CHARLOTTE-MECKLENBURG PLANNING COMMISSION
INTER-OFFICE COMMUNICATION

SUBJECT: Administrative approval for petition #89-72 by Southern Realty Dev. Corp. Tax Parcel #082-169-01

Project: PLAZA MATHESON CENTER
Sheet Title: REZONING PLAN (MODIFIED)

Project Number: JMA JOB # 239.001
Sheet: R-2

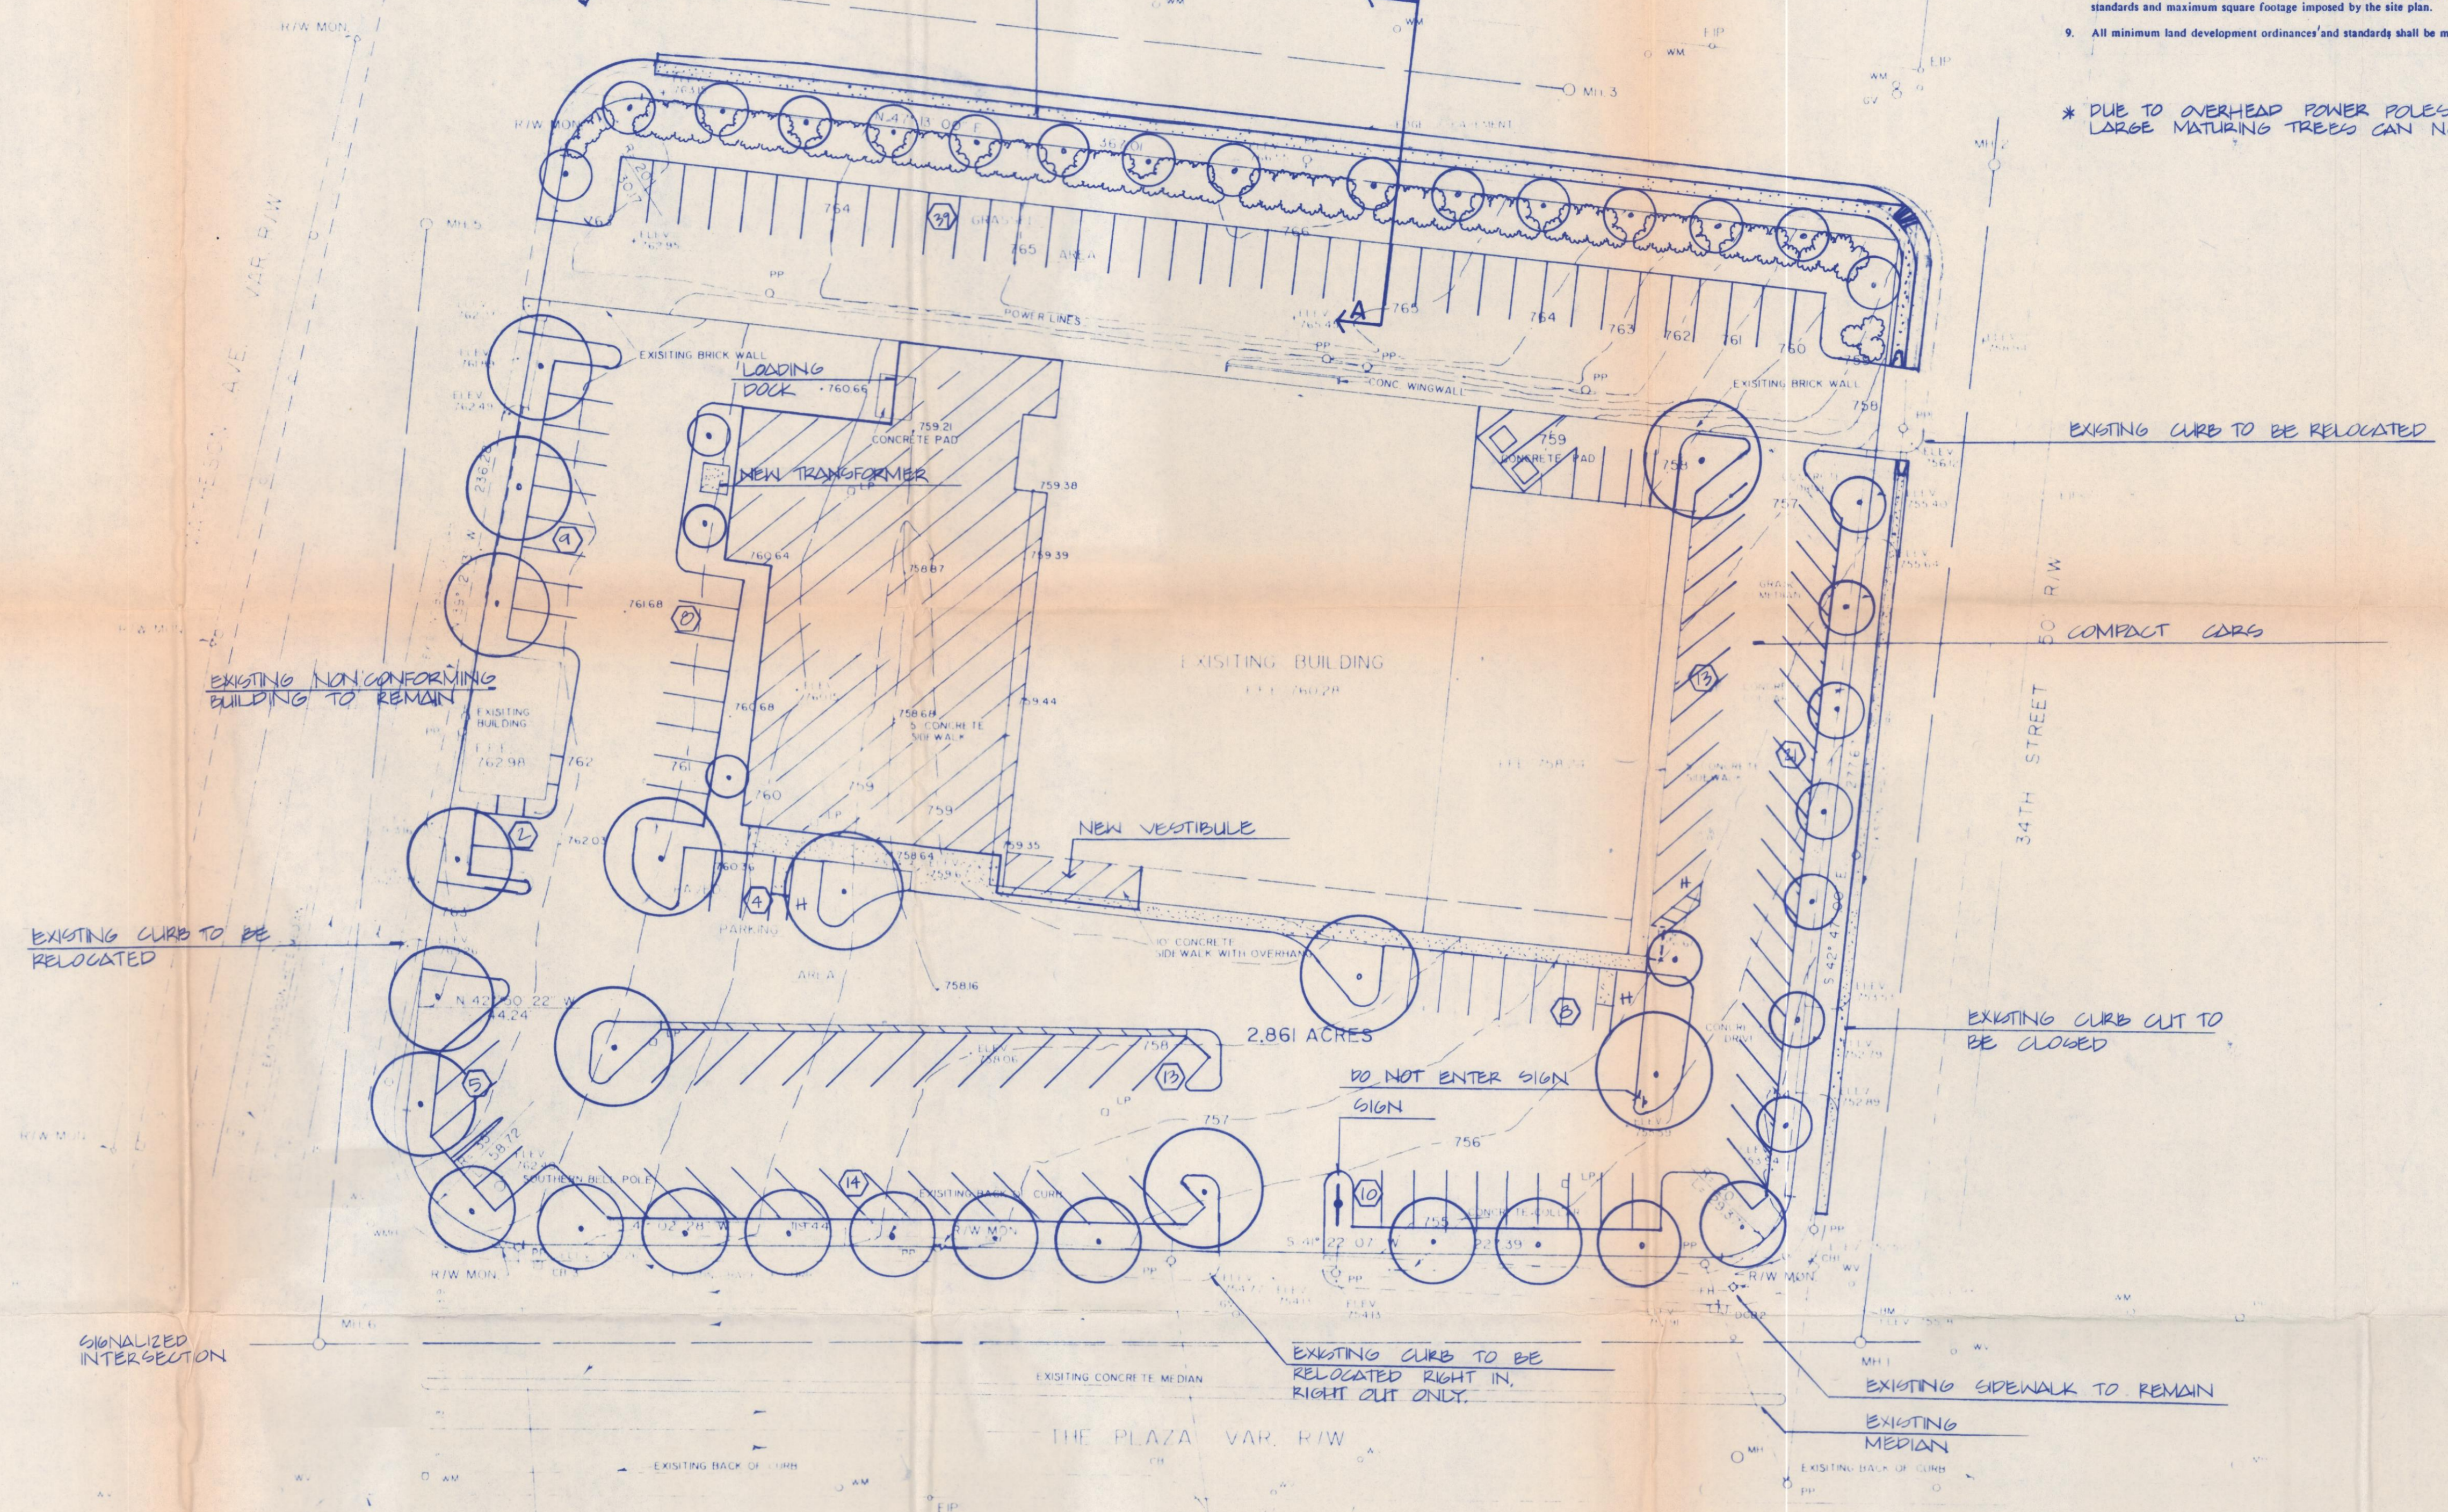
Attached is a revised plan for the above mentioned petition. The plan has been revised to eliminate a retaining wall at the rear of the site. A preliminary grading plan has been done and the need for retaining was eliminated. The wall has been replaced with a two to one slope. The screening at the rear has been supplemented with an additional row of shrubs.

Pursuant to my authority as outlined in the zoning ordinance I am administratively approving this plan. Please use it when evaluating requests for building permits.
